Bradley Heights

PROJECT DESCRIPTION
 SITE DEVELOPMENT IMPROVEMENTS, INCLUDING CLEARING, GRADING, RETAINING WALLS, PARKING LOT, STORM DRAINAGE, SANITARY SEWER MAIN, WATER MAIN FOR 238 UNIT MULTI-FAMILY DEVELOPMENT.

SITE ADDRESS:
 202 27TH AVE SE

Grading Plan
 Bradley Heights
 Timberlane Partners
 1816 11th Ave Unit C
 Seattle, WA 98122
 Phone 206.886.0326
 Fax jordan@timberlanepartners.com

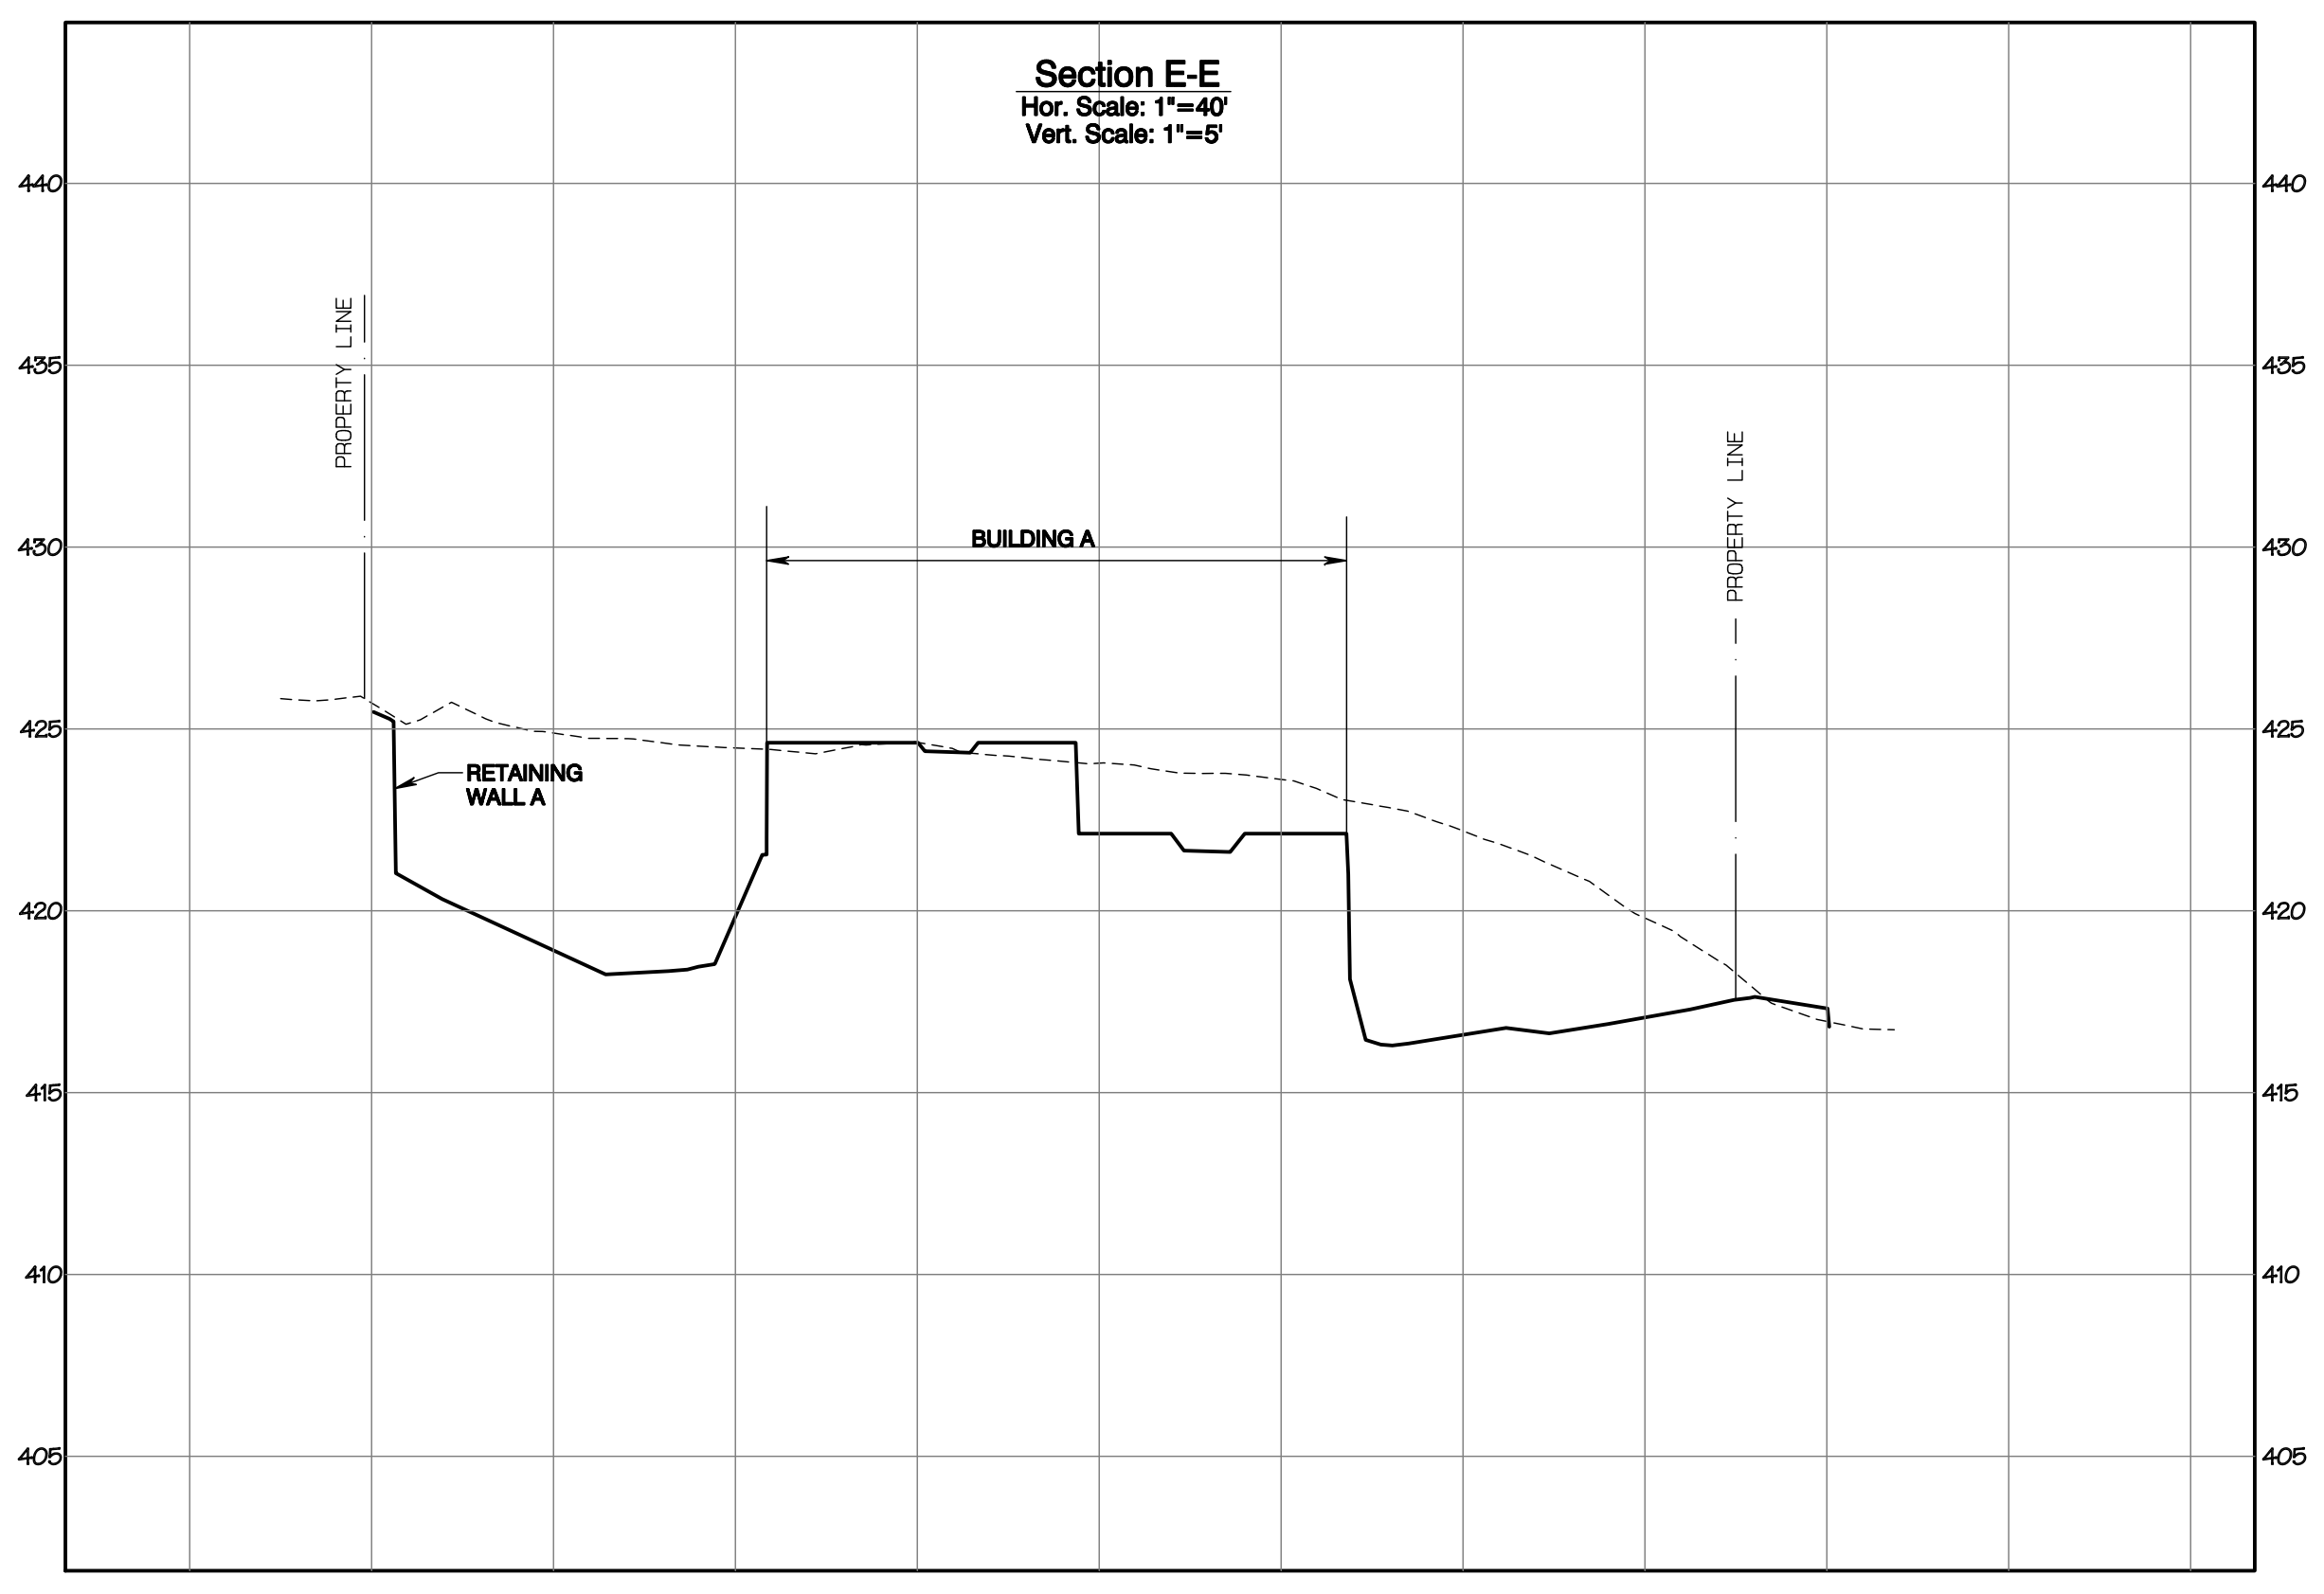
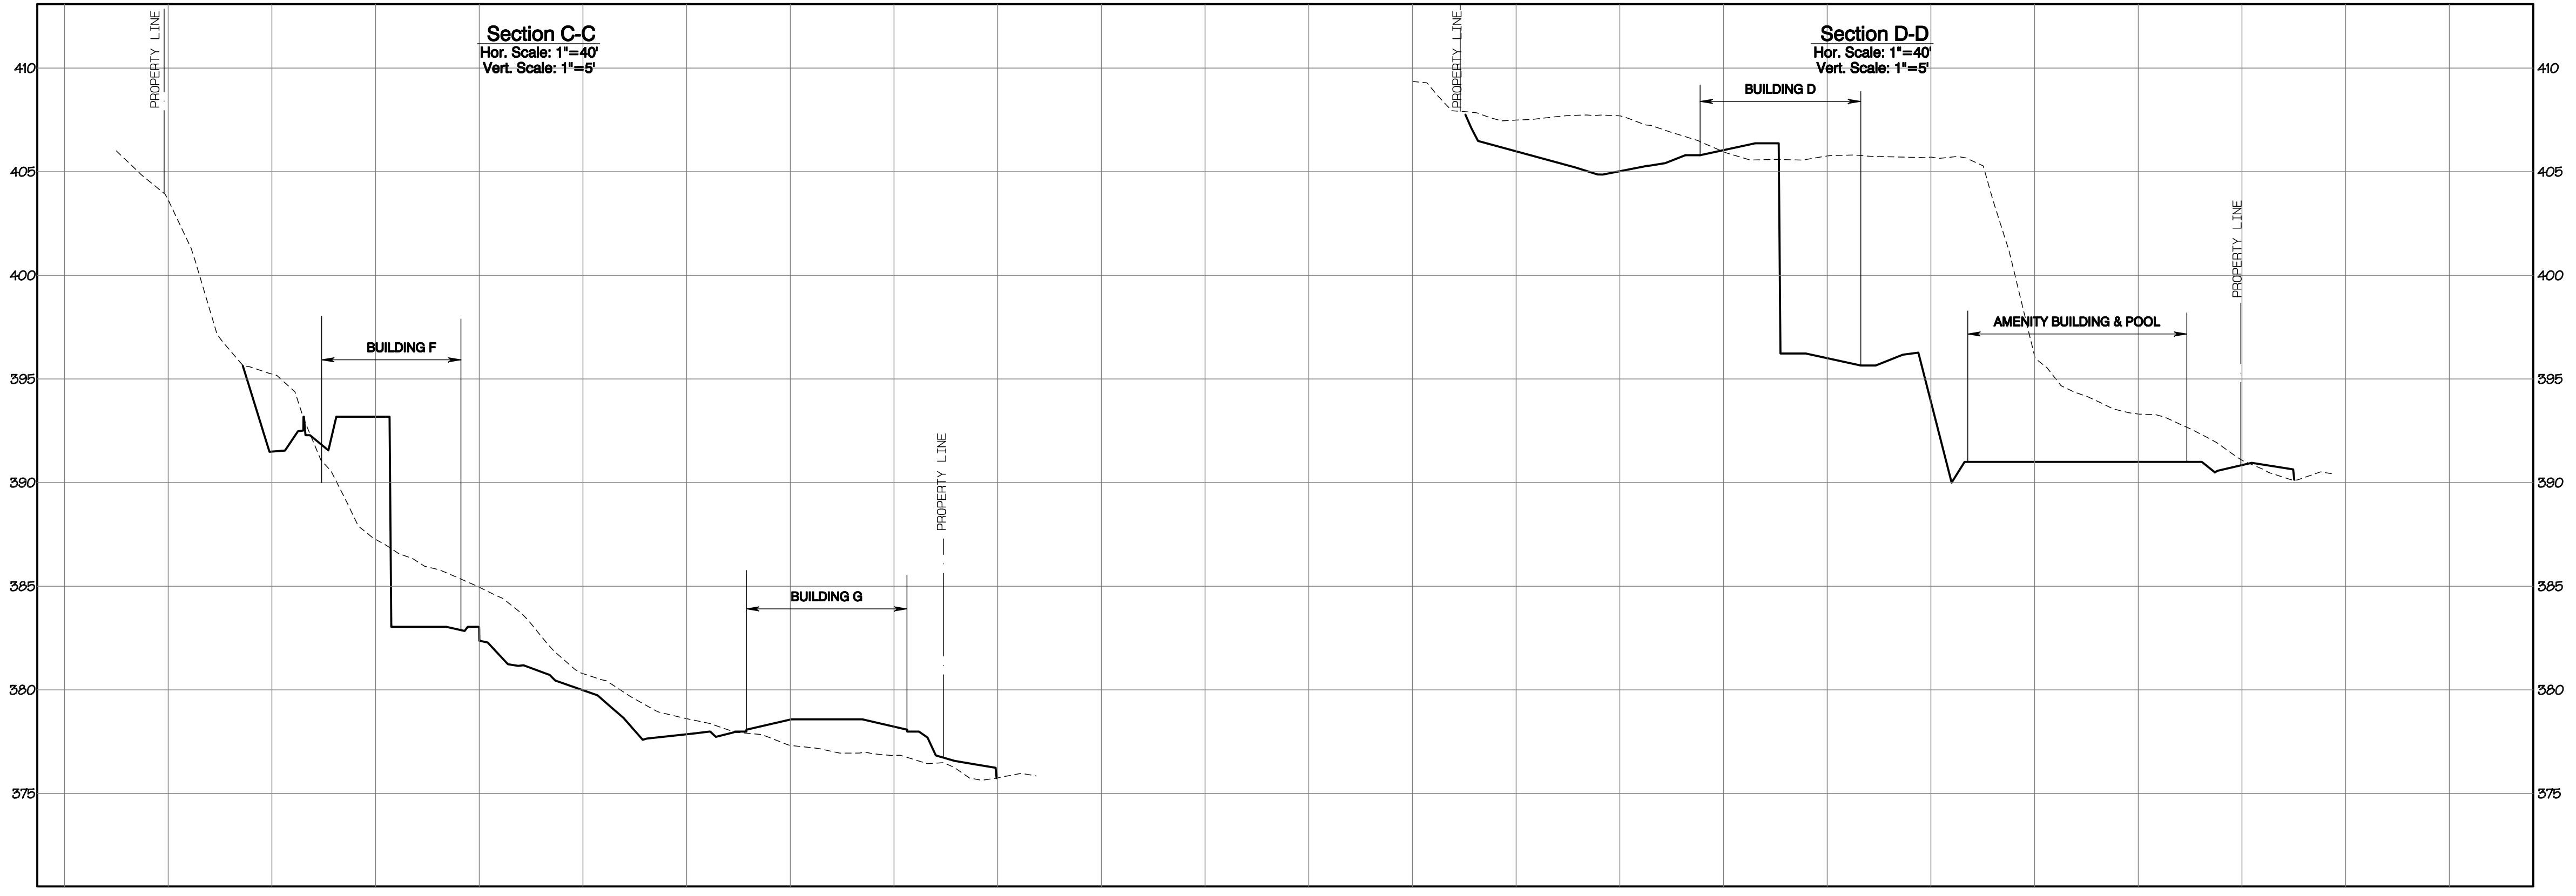
Label walls consistently with details on G12 and G13. Label as wall A, Segment 1 and include label for Wall A, Segment 2. [CIVIL PLANS, Sheet G8]

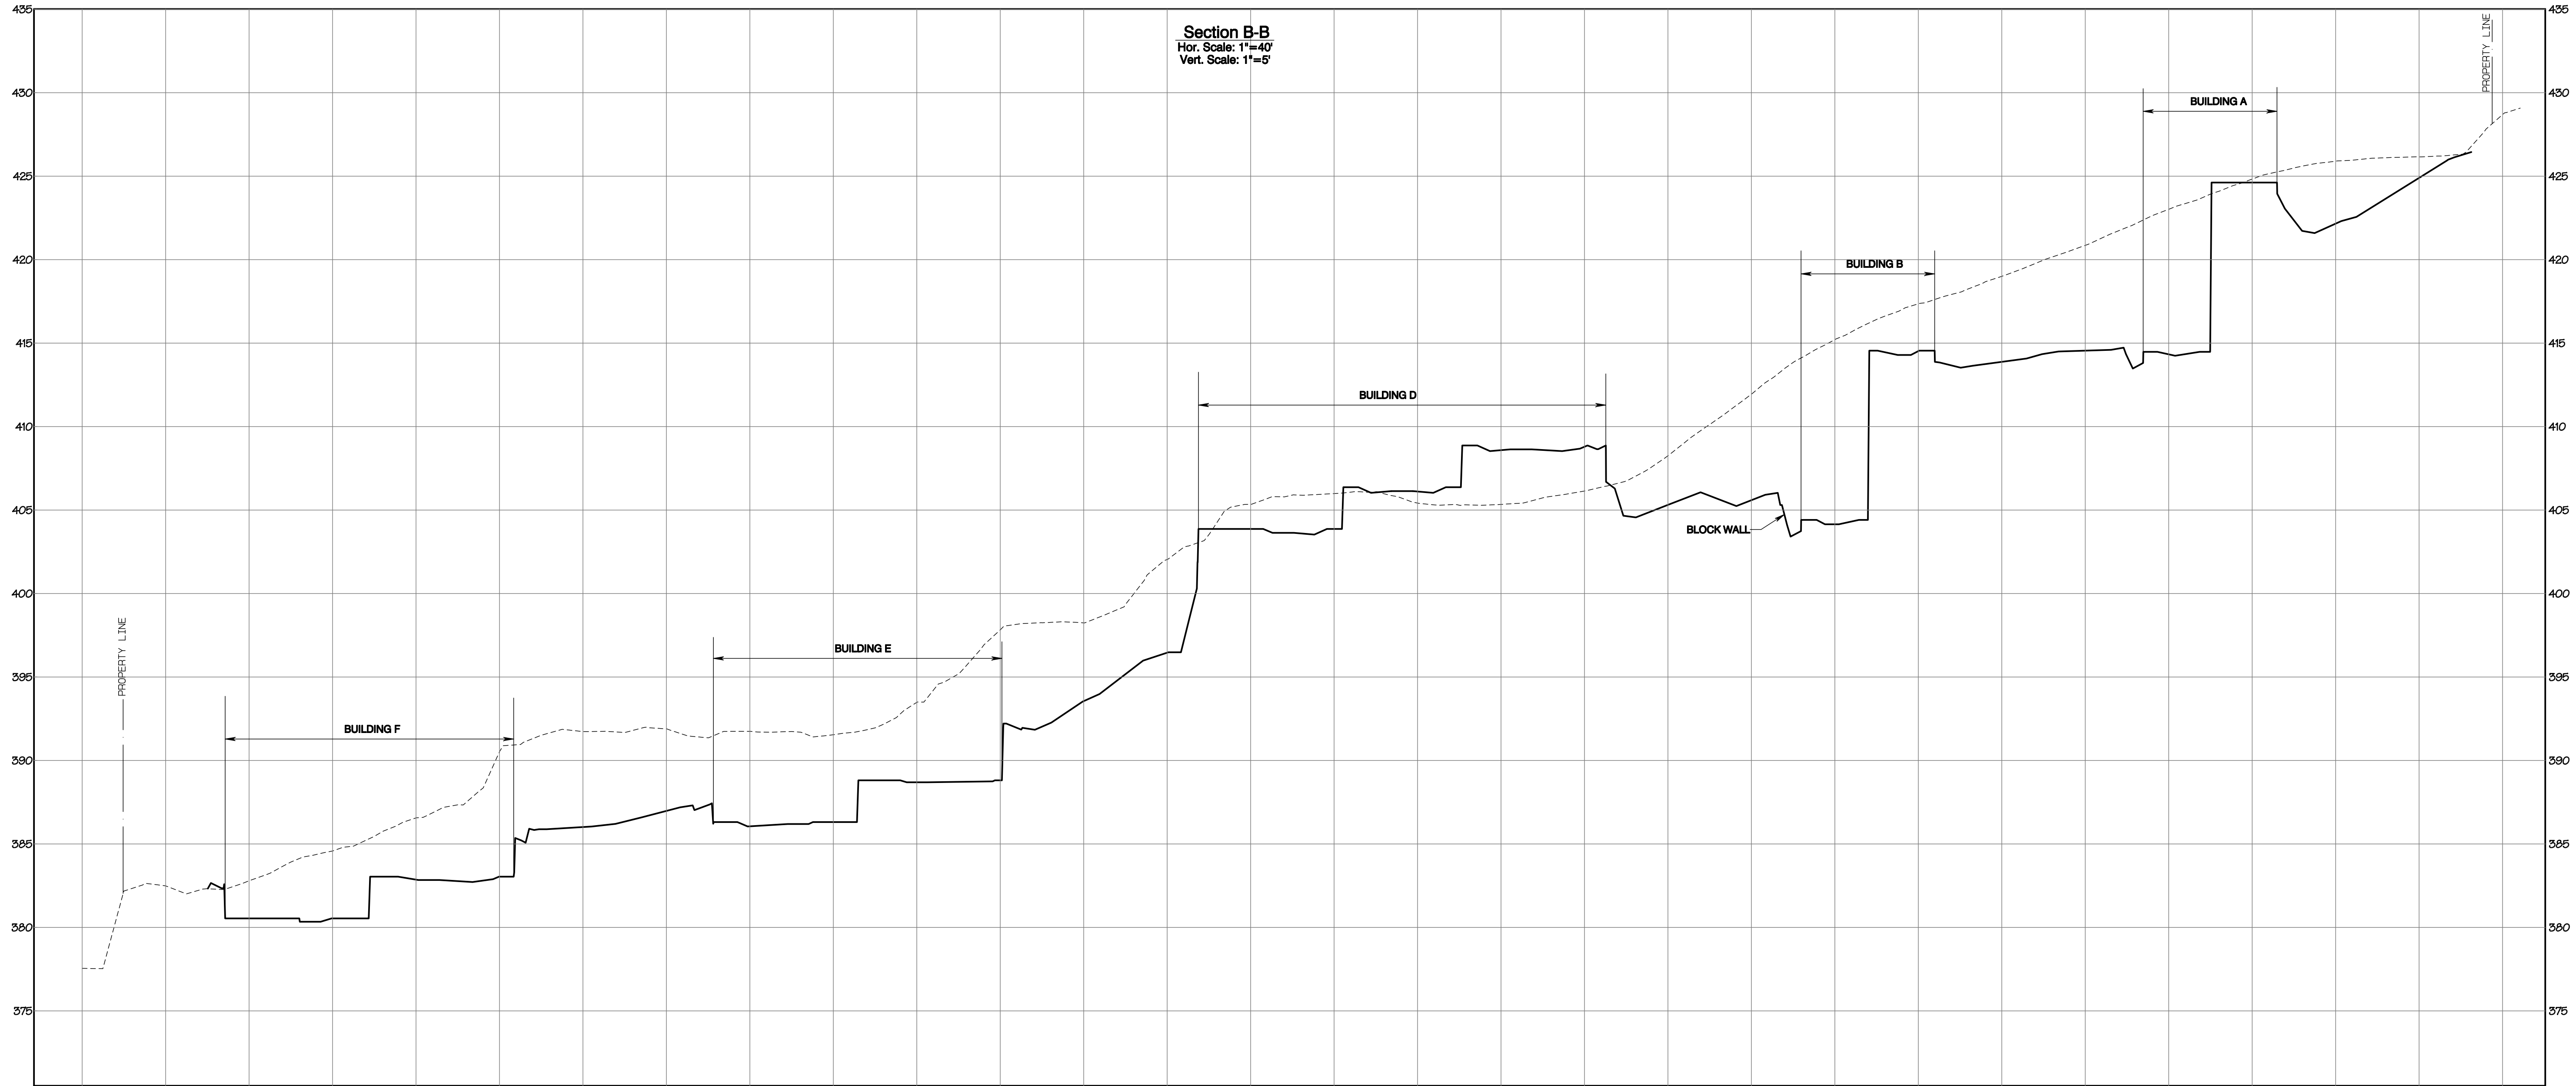
For next submittal refine or clarify proposed (solid line) ground level within these cross-sections. [CIVIL PLANS, Sheet G9]
